Engineering Evaluation of Bollard Fence

Rio Grande, Hidalgo County, Texas

United States of America v. Fisher Sand and Gravel Company, Civil Action No. 7:19-CV-403

August 2021

Figure 4.1. TGR HEC-RAS model domain

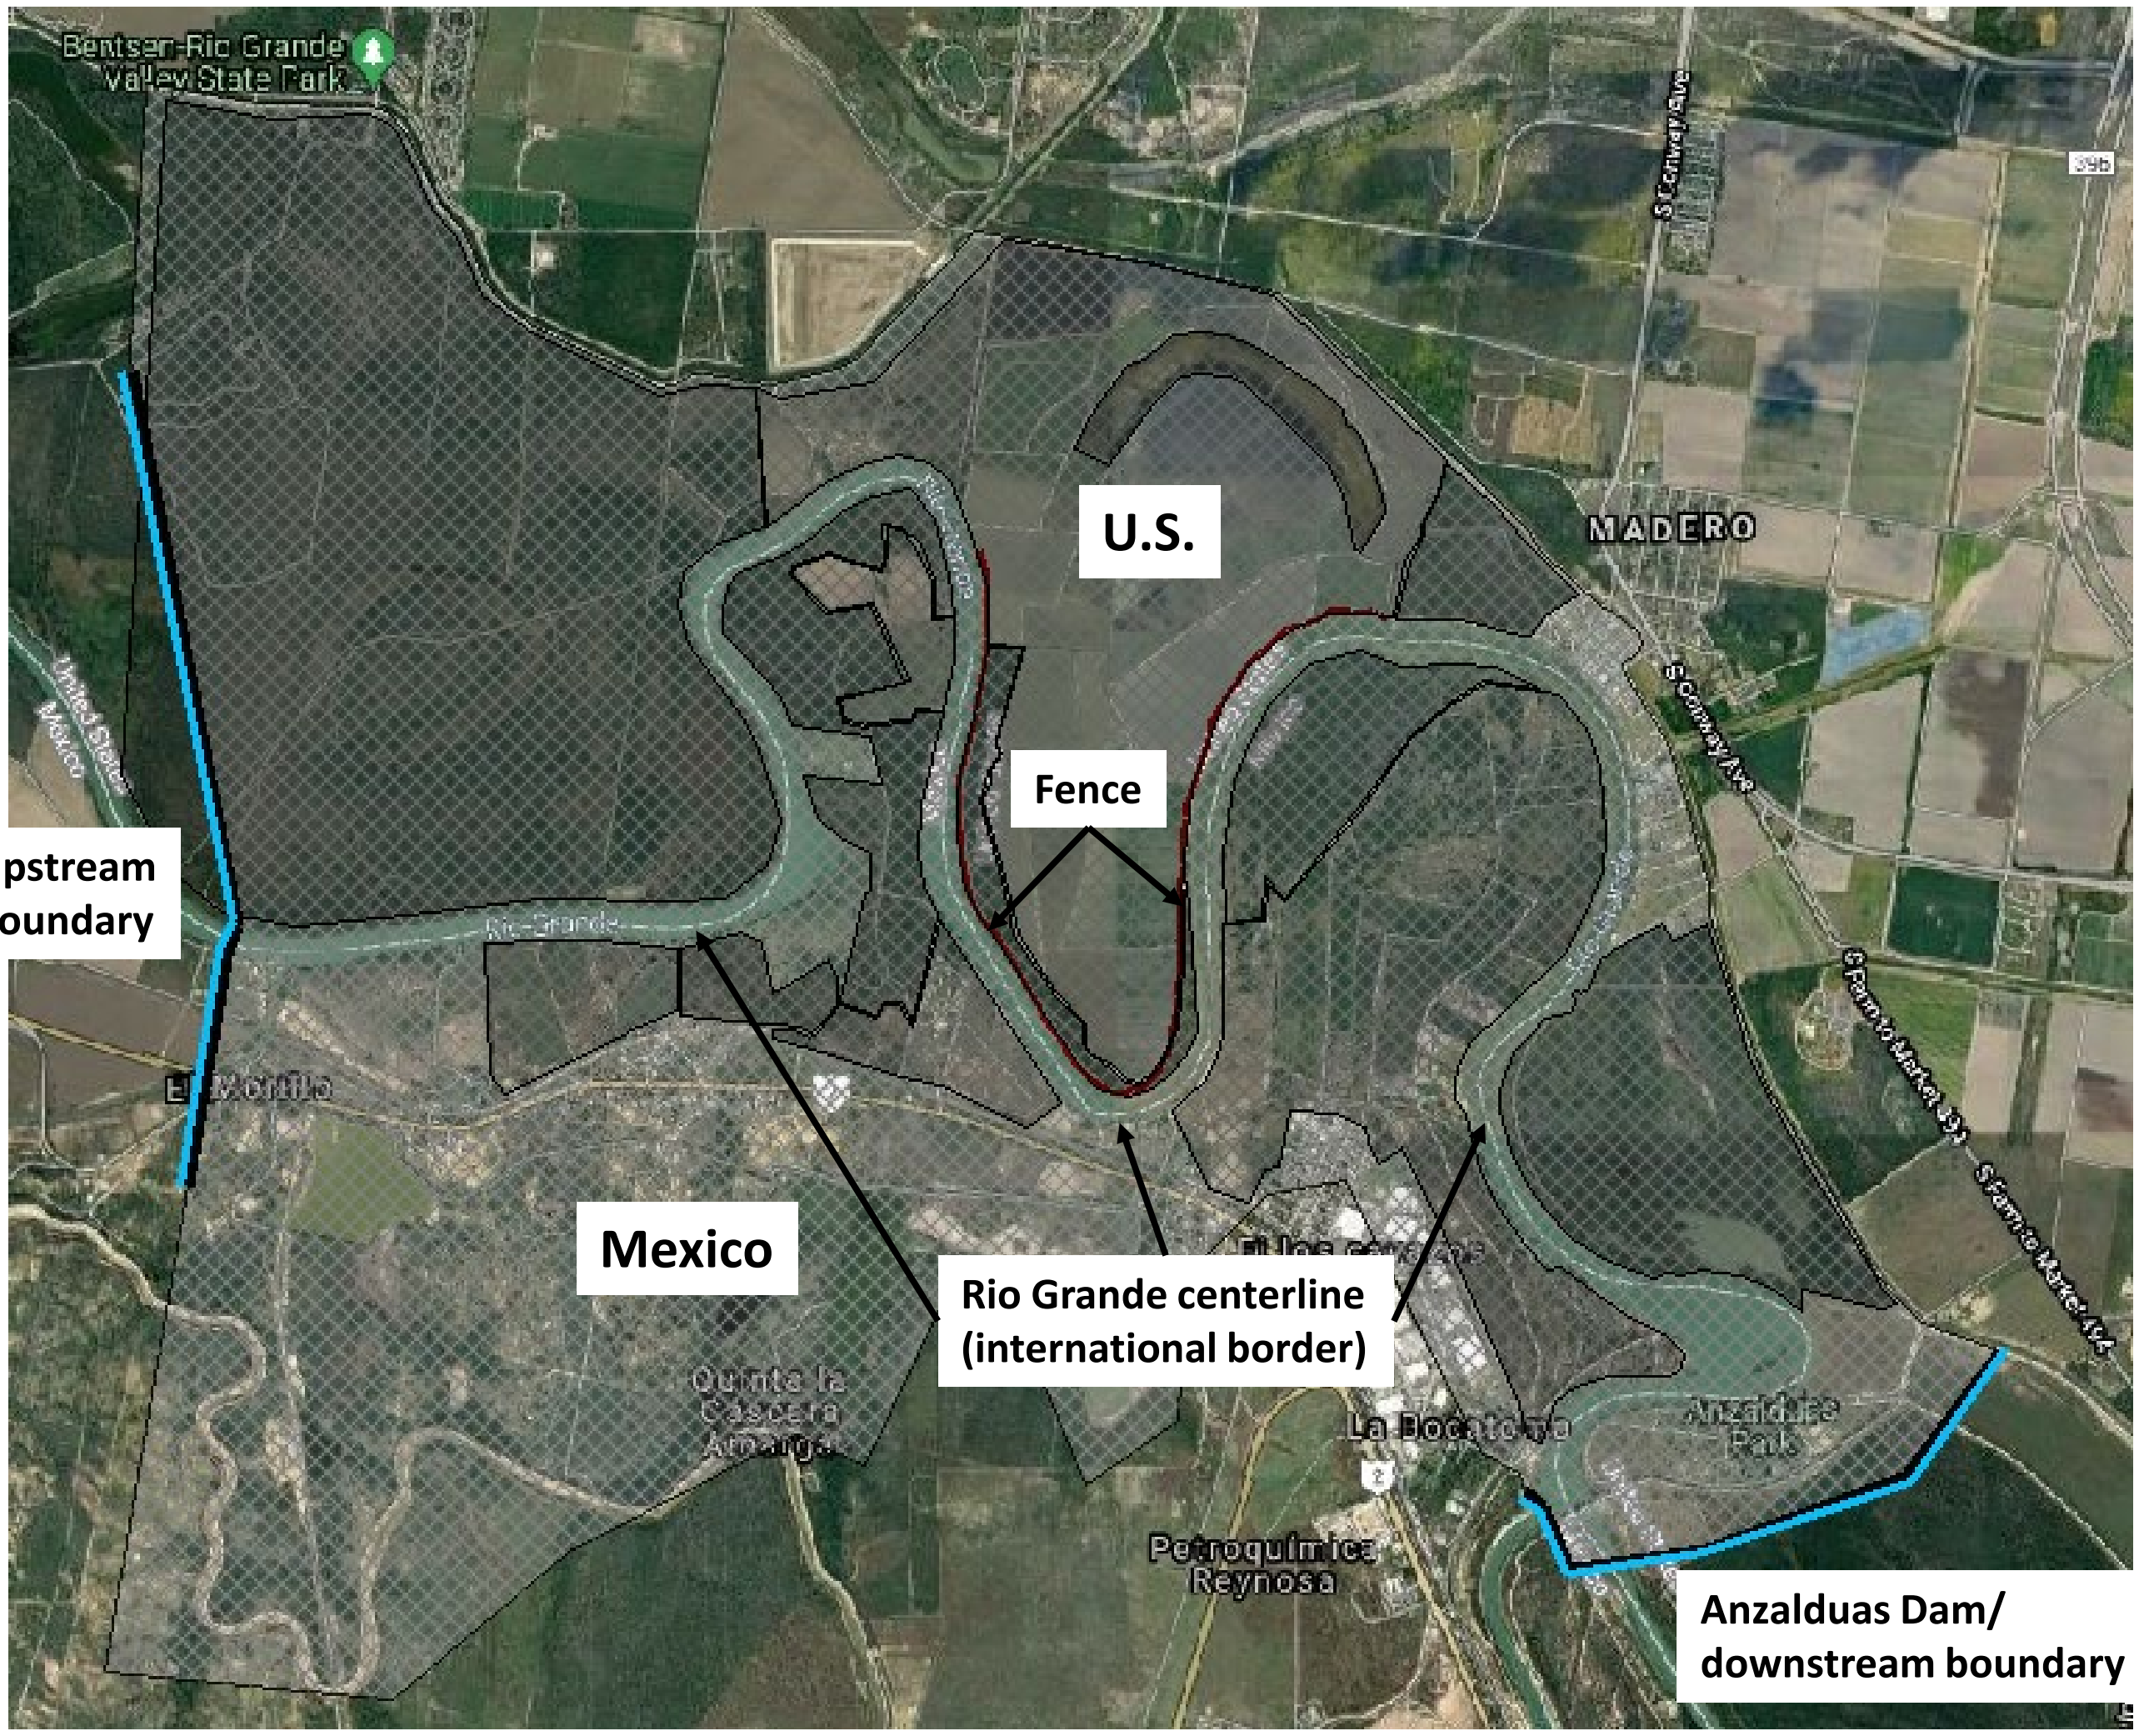
The TGR HEC-RAS model domain, shown in Figure 4.1, extends approximately 9 river miles upstream of Anzalduas Dam. The model is fully two-dimensional with a variable grid covering the Rio Grande river and floodplains on the U.S. and Mexico sides of the river to the domain boundaries. Cell face lengths average 2 feet adjacent to the fence, increasing to 50 feet in the river and floodplains moving 150 feet from the fence. The model was developed using HEC-RAS version 5.0.7 (United States Army Corps of Engineers [USACE] 2019).

Figure 4.2. TGR bollard fence and virtual pier terrain (enlarged)

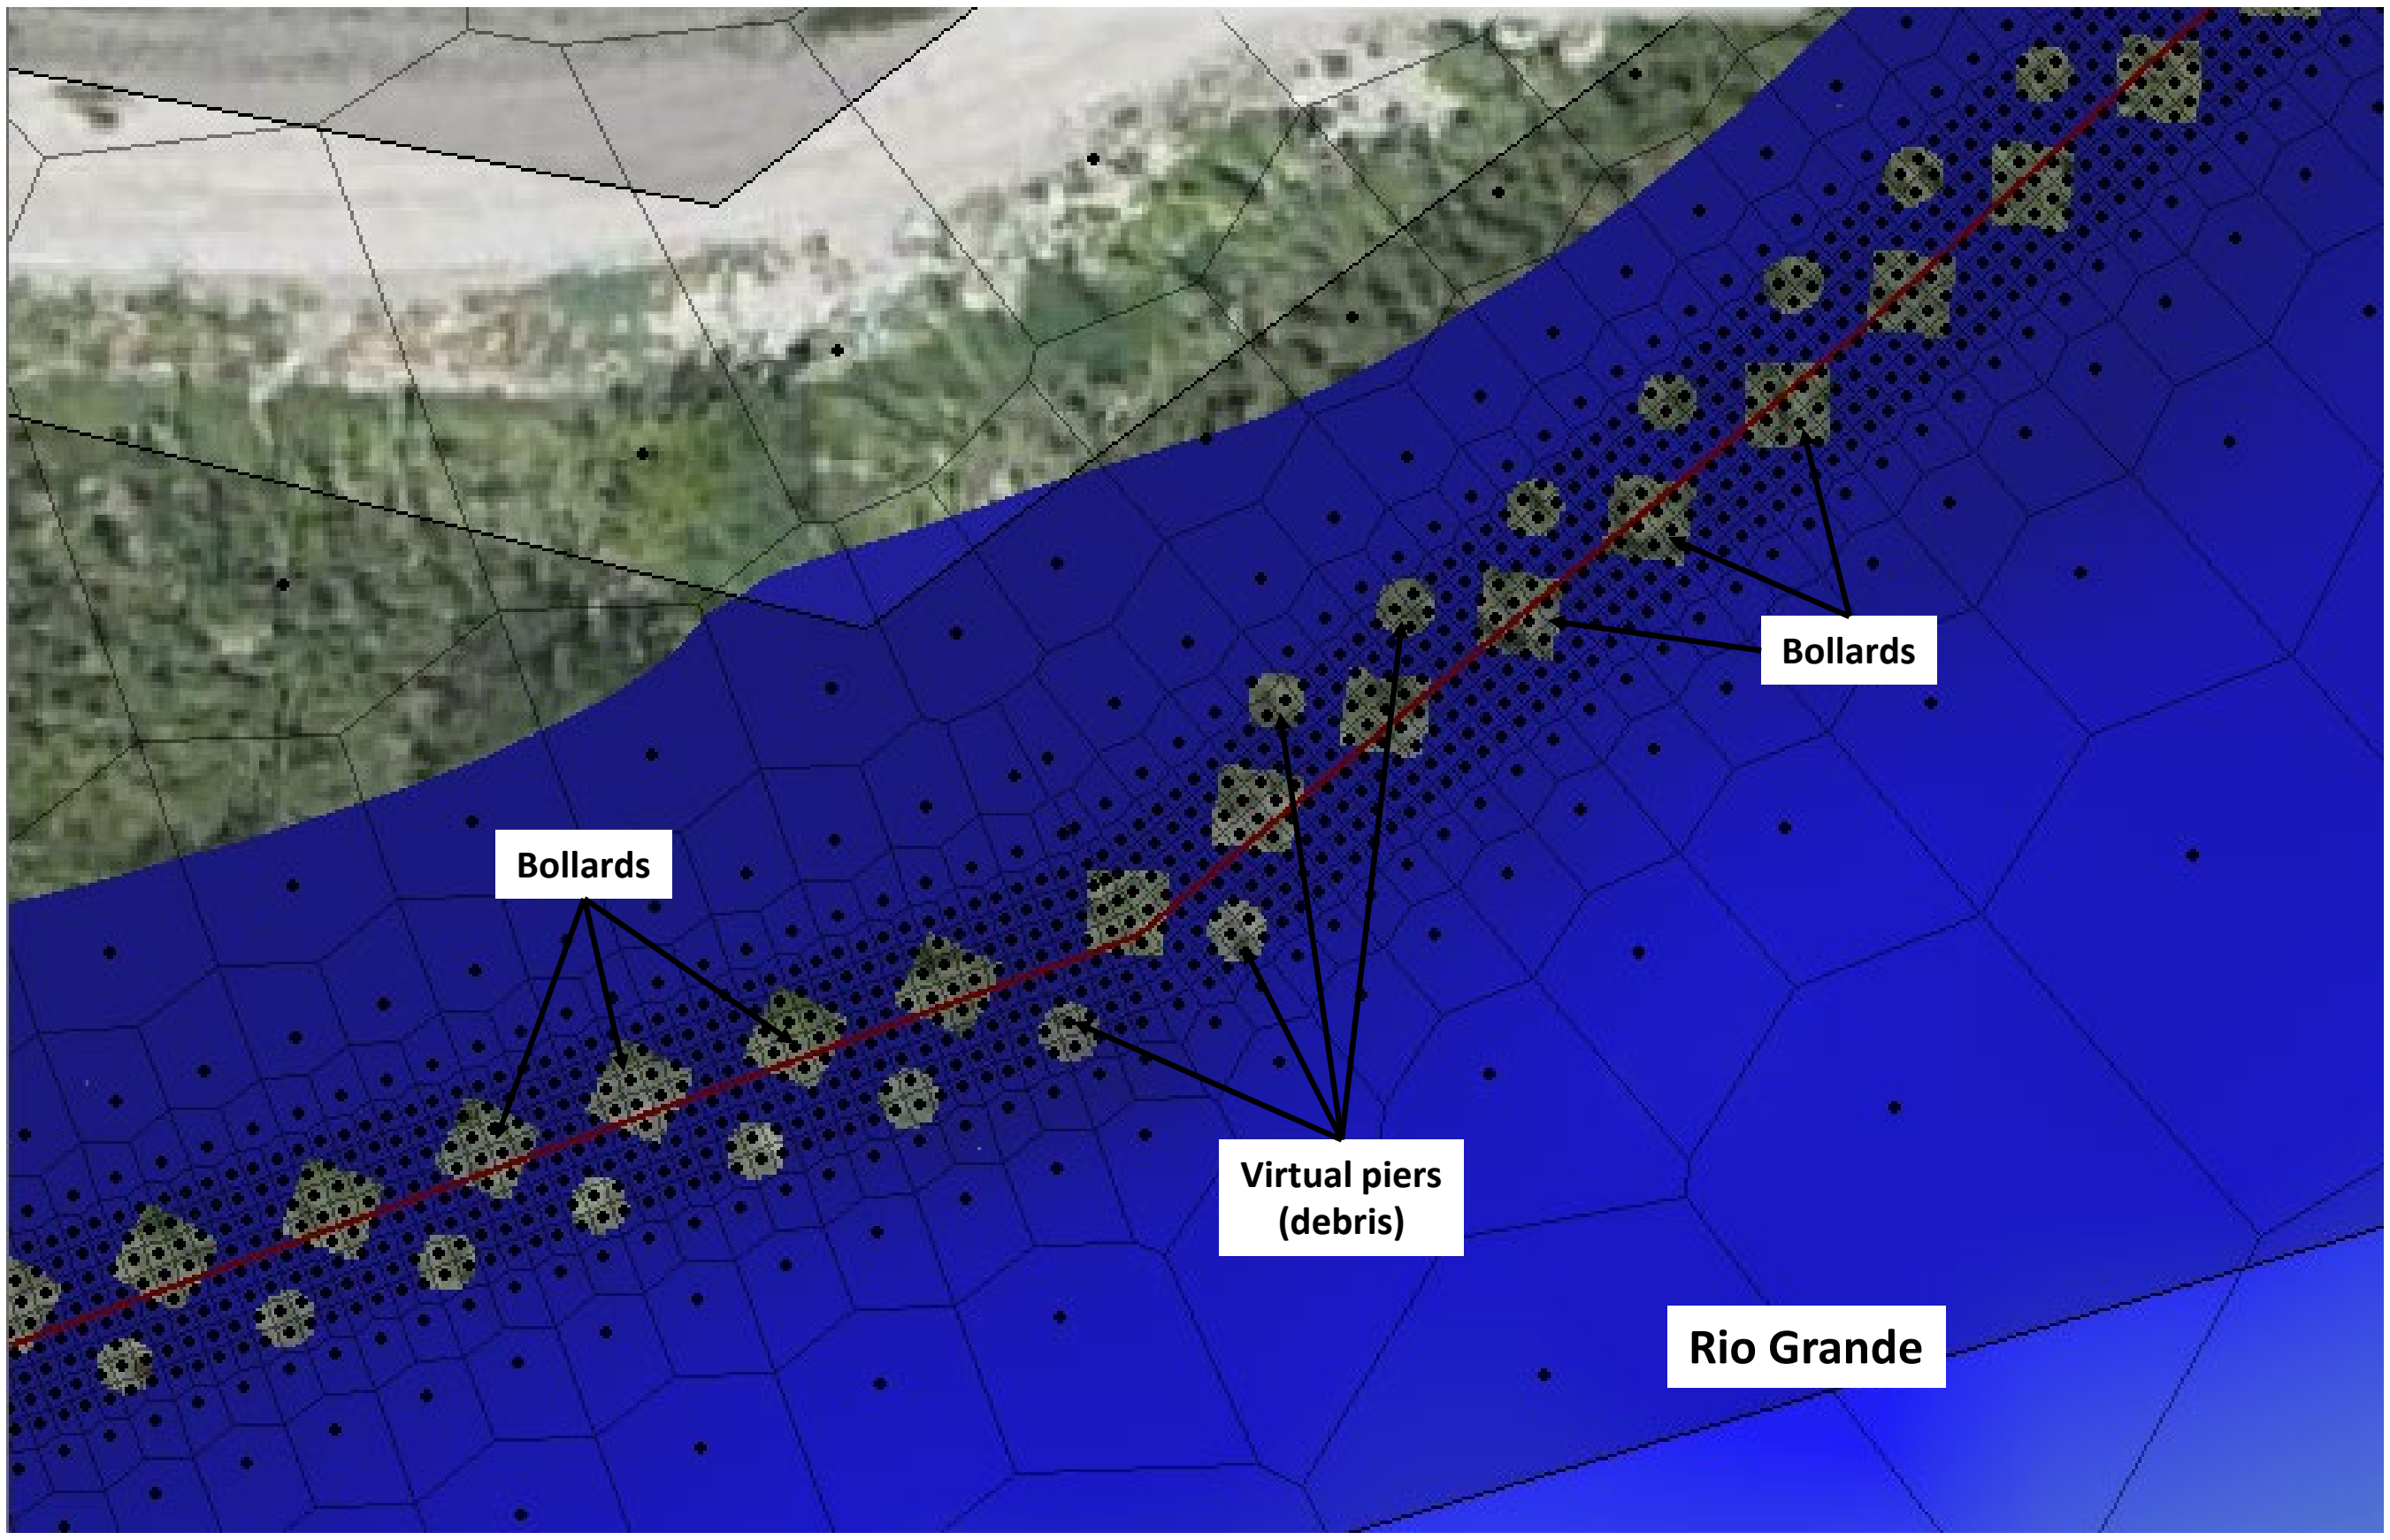
The post-project terrain also includes a 12:1 horizontally distorted bollard fence, constructed so that horizontal dimensions in inches map to the same number of feet, i.e., a 5-inch spacing between bollards becomes 5 feet, and 6-inch square bollards become 6-foot square bollards. The TGR model appears to interpret IBWC guidelines (IBWC undated) requiring 30 percent debris blockage as blockage of each bollard opening, although the model report does not explain how blockage was effected. Examination of the post-project model terrain shows virtual cylindrical piers approximately 4 feet in diameter centered about 5 feet in front of (river side) or behind (land side) each 5-foot fence opening, presumably to represent debris blockage although this is not confirmed in the text of the report. An enlarged view of the bollard and pier configurations represented in the TGR model is shown in Figure 4.2.

By distorting the horizontal dimensions of the bollard fence by a factor of 12, the 2D TGR model does not preserve hydraulic similitude. For any given river flow depth and velocity, flow and turbulence around 6-foot bollards spaced 5 feet apart are not similar to flow around 6-inch bollards with 5-inch openings. As shown in Figure 4.4, the TGR model simulates large (10 to 20 feet) whirls and eddies along the riverbank and fence, which ordinarily would not be expected to occur with river flow velocities between 2 and 4 fps. In addition, velocities of 8 to 10 fps are shown in Figure 4.5 at the downstream terminus of the fence where velocities would be expected to fall as the reservoir fills. Large-scale turbulence and high velocities simulated by the TGR model do not appear to accurately characterize river and floodplain hydrodynamics with flow velocities averaging less than 4 fps as simulated by the subsequently described Arcadis HEC-RAS model. The TGR report does not disclose high velocities and turbulence simulated by its model and does not propose or discuss mitigation measures.
